## 300 Studebaker Road Industrial Park Project

### Final Initial Study – Mitigated Negative Declaration

# 1 Responses to Comments on the IS-MND

FIGURE 7

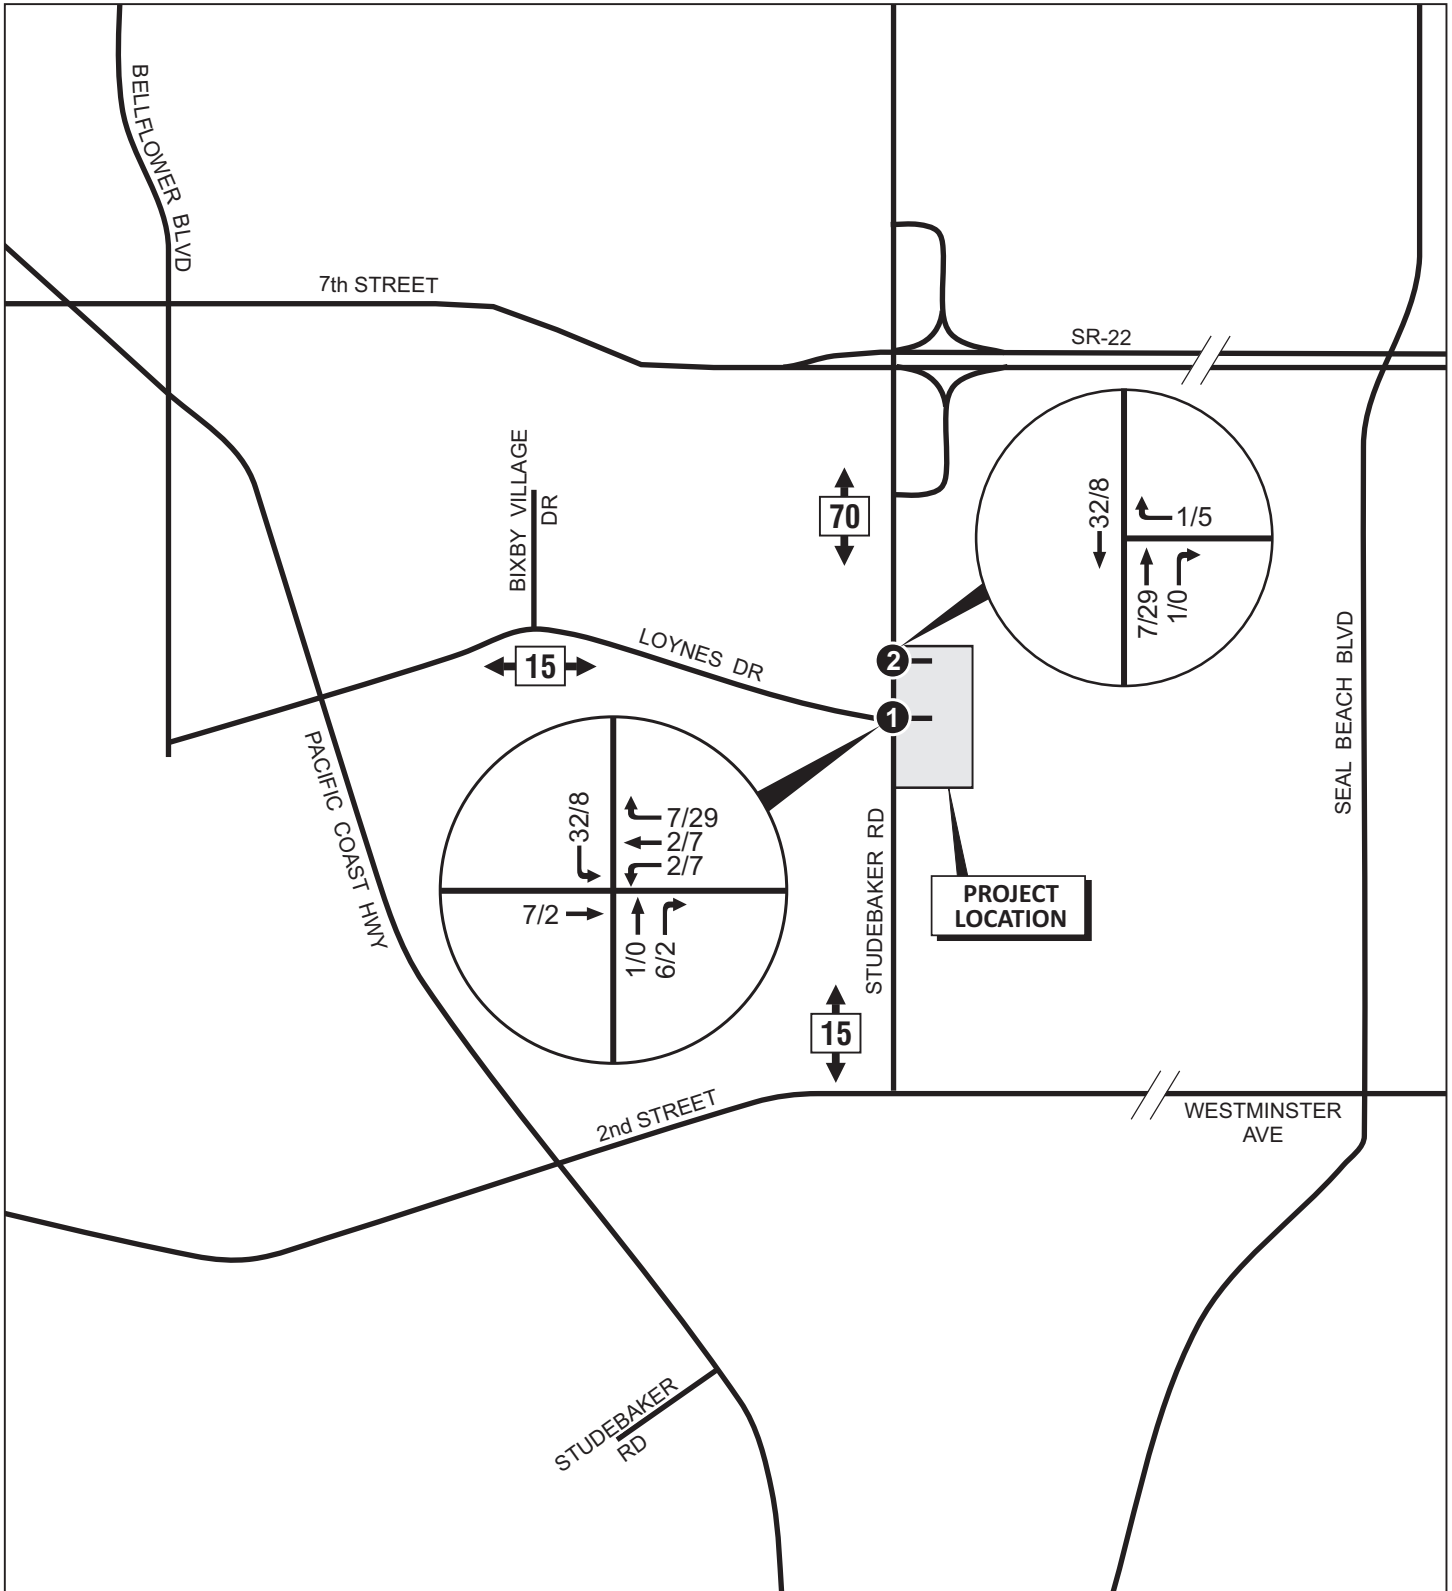
1. Generates over 100 peak hour trips assigned to a State highway facility  
Per Figure 7 of the TIA, the project would generate a maximum of 34 p.m. peak hour trips towards any State Highway Facility (Pacific Coast Highway or SR-22). This is below the 100 peak hour trip threshold.

2. Generates 50 to 100 peak hour trips assigned to a State highway facility – and, affected State highway facilities are experiencing noticeable delay; approaching unstable traffic flow conditions (LOS “C” or “D”).  
Per Figure 7 of the TIA, the project would generate a maximum of 34 p.m. peak hour trips towards any State Highway Facility (Pacific Coast Highway or State Route 22). This is below the 50-100 peak hour trip threshold.

Figure 7 of the TIA illustrates the project trip assignment. Based on the trip distribution of the project trips (including both passenger vehicles and trucks), only a portion of project traffic would use Pacific Coast Highway or SR-22. During the p.m. peak hour, 34 trips (PCEs) would be expected to travel north of the project site on Studebaker Road towards SR-22. Along Loynes Drive, headed westbound, there is expected to be seven project trips during the p.m. peak hour, as trucks are not allowed to travel on Loynes Drive.
